### PREDEVELOPMENT PLAN REVIEW COMMENTS

**Project Number:** PPR2021-00006 **Date:** August 5, 2021  
(Revised August 19, 2021)

**Project Address:** 280 Ramona St. / 279 E. Holly St.

**Project Description:** Predevelopment Plan Review for a new 5-story 112 unit senior affordable housing project with on-site amenities, semi-public courtyard, and one level of subterranean parking with 44 parking spaces.

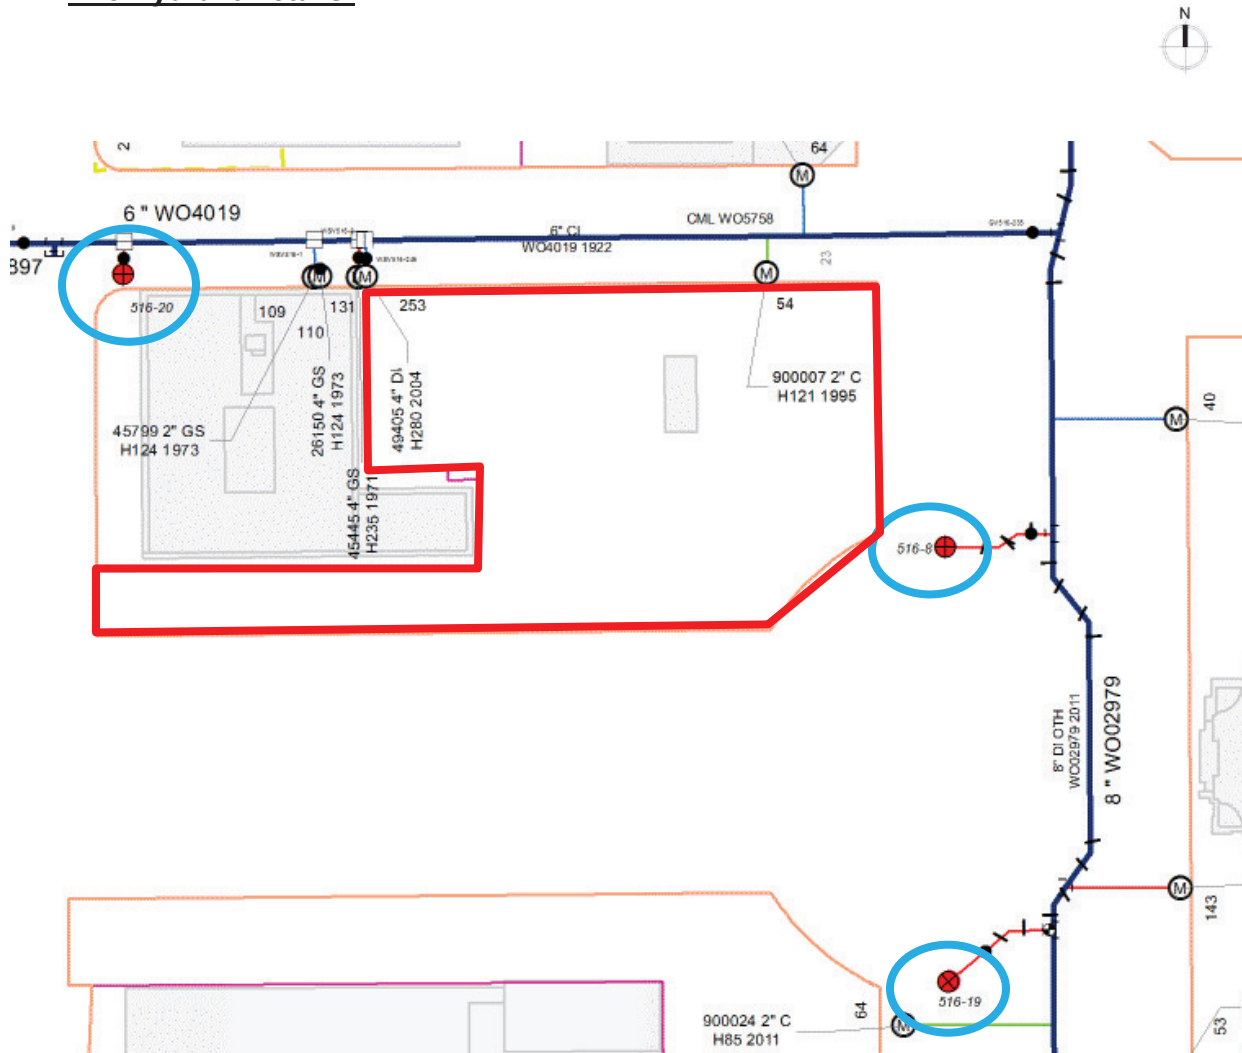
There are three fire hydrants in close proximity to the project site:

- Fire hydrant 516-8 is located on the west curb of Garfield Avenue, approximately 130 feet south of Ramona Street.
- Fire hydrant 516-9 is located on the west curb of Garfield Avenue, approximately 170 feet north of Union Street.
- Fire hydrant 516-20 is located on the southeast corner of Marengo Avenue and Ramona Street.
